City of Surrey  
**PLANNING & DEVELOPMENT REPORT**

File: 7910-0214-00

in order to permit the development of an Animal Care and Adoption Centre.

# Advisory Design Panel Minutes

SITE PLAN

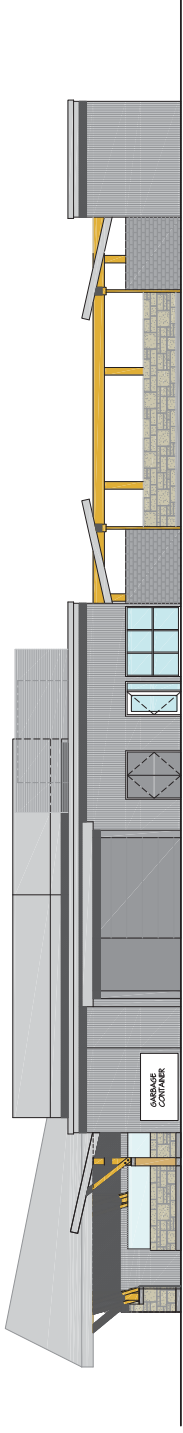
- Turning radius for buses is a concern.

- Support the on-site storm-water management. The bioswale area could be larger in this context.

*(The turning radius lines for both buses & fire trucks will be shown on the site plan.)*

*(The bioswale extends along the entire east side of the parking lot, and then continues along the south side and returns north alongside the west driveway. All of the drainage from these areas will be into the bioswale, with no catch basins. Two retention ponds will hold and allow the water from both the building roof and the parking/driveways to naturally drain into the ground. During periods of heavy, continuous rain, the retention pond will overflow into the drainage ditch alongside Colebrook Road, where the water can similarly drain into the surrounding agricultural lands.)*

WEST ELEVATION  
SCALE: 1:100

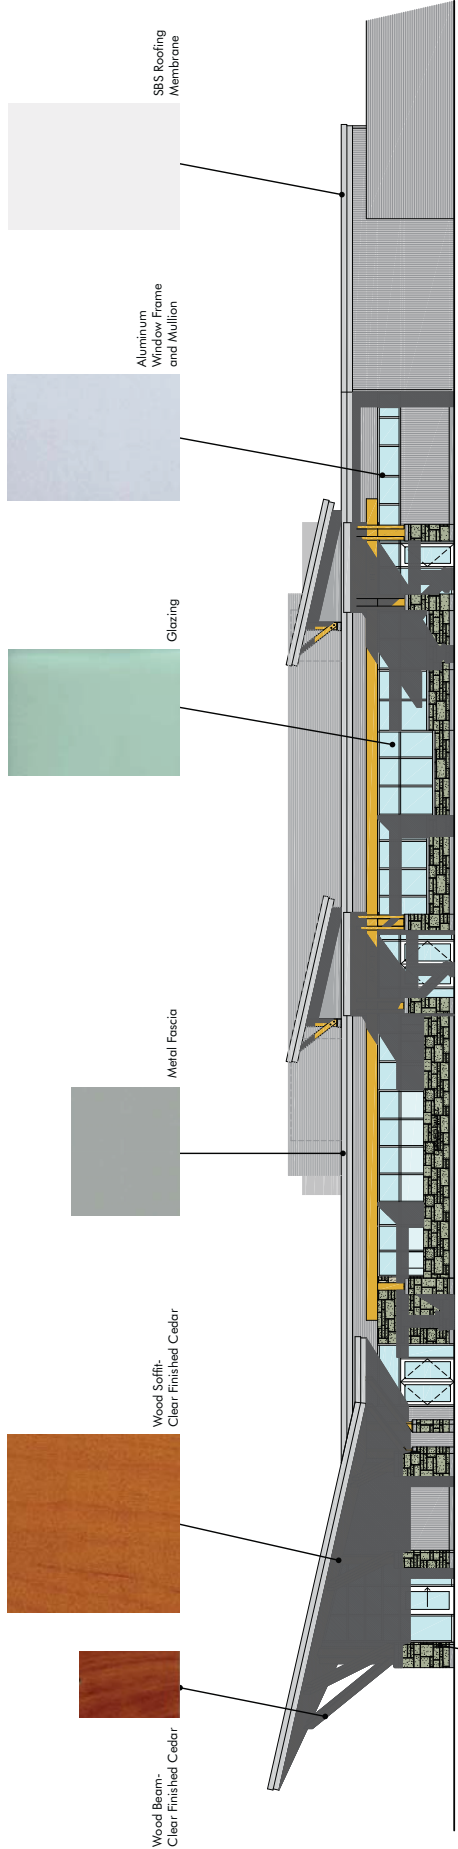
- The west entrances could be resolved differently. Could be the way the foreground is treated. There are three significant entrances, that could be made into a more pedestrian element and provide shading to the glass. There is more that could be done with the exterior to unify the three entrances. Consider providing a major walkway as a long front porch that leads into the other three entrances. Pedestrians could walk up to the “porch” and then have three entrances to select.

- The arrival sequence is not as well defined as it should be. It is a challenge that two of the three entrances are treated similarly. It may be confusing to know what door to go to. Should not rely on signage to do the job. There should be a hierarchy of spaces as the building is approached.

- Recommend more shade for the west facade with overhangs or shade trees (deciduous).

*(Each of the three public entrances into the facility serves a distinct function/group and are kept separated to avoid conflicts — one entrance is for those who are coming to adopt (depart with an animal), another is for those who are coming to surrender an animal (arrive with an animal), and the third is for those who are coming to obtain services for their animal (arrive with an animal for training, boarding, etc.)*

*(Each entrance is of equal importance, though the “main” building entrance where the business counter is also located is centrally located and has the widest canopy and entry doors complete with glazing. People arriving at this location can be redirected to one of the other two nearby entrances if necessary.*

*(The large, deep horizontal beam along the front (west) façade provides significant shading to the glazing beyond. A row of deciduous (Katsura) trees immediately in front of this beam will also shade the west side of the building during the summer months.)*

NORTH ELEVATION  
SCALE: 1:100

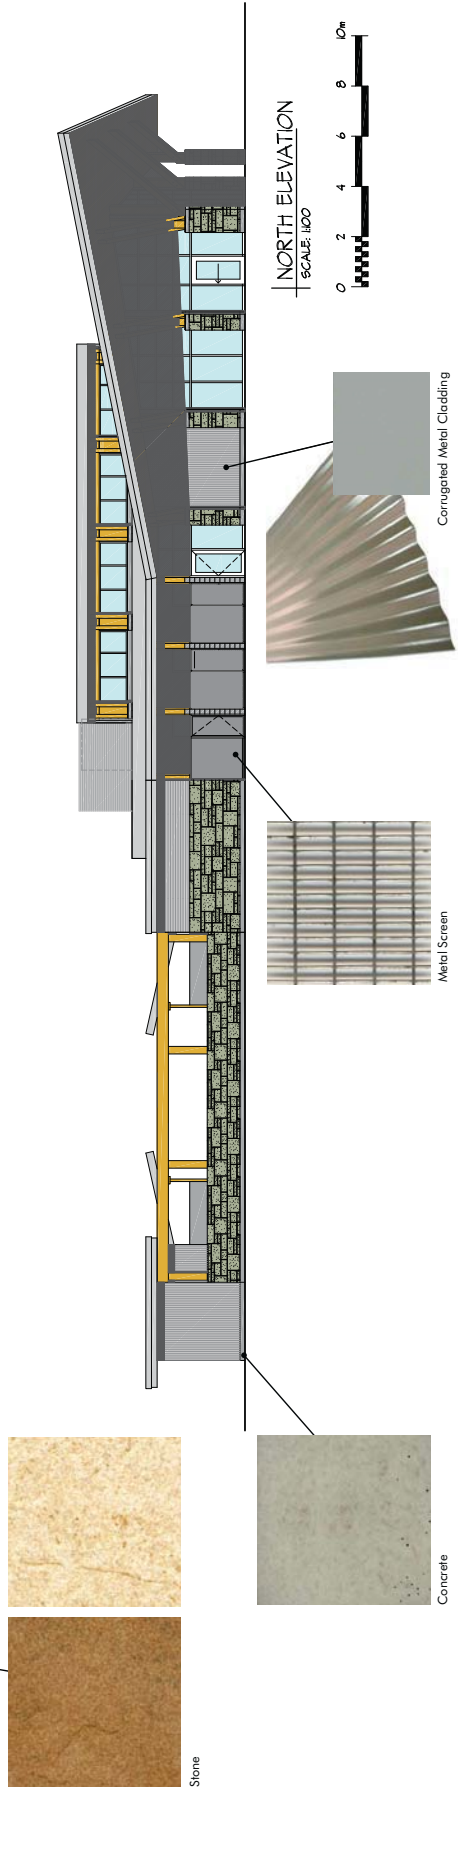
- The skewed classroom requires design review and development. The architecture is a mainly linear. Pitching and turning the roof appears awkward. Consider sloping the roof in one direction and glazing the entire corner.

- As a special element, the corner should have glass all the way around with special detailing treatment.

*(The roof slopes/geometry have been reviewed via design modelling and are being finalized with the engineering consultants; sloped roofs are also used at the building entrances both as canopies and to create vaulted spaces inside.*

*Glazing the remaining solid walls will be counter-productive to the classroom function — areas of solid wall are required for instruction purposes and screening the view of the exterior entrances and the parking lot will minimize the visual distractions for dogs that may be participating in socialization or obedience training with their owners. Large glazed walls are provided to the north (front lawn) and west (terrace) for passive views.)*

*(Refer to the answer above — the possibility of providing additional glazing high in the solid walls (immediately below the roof) is being further explored by the design team.)*
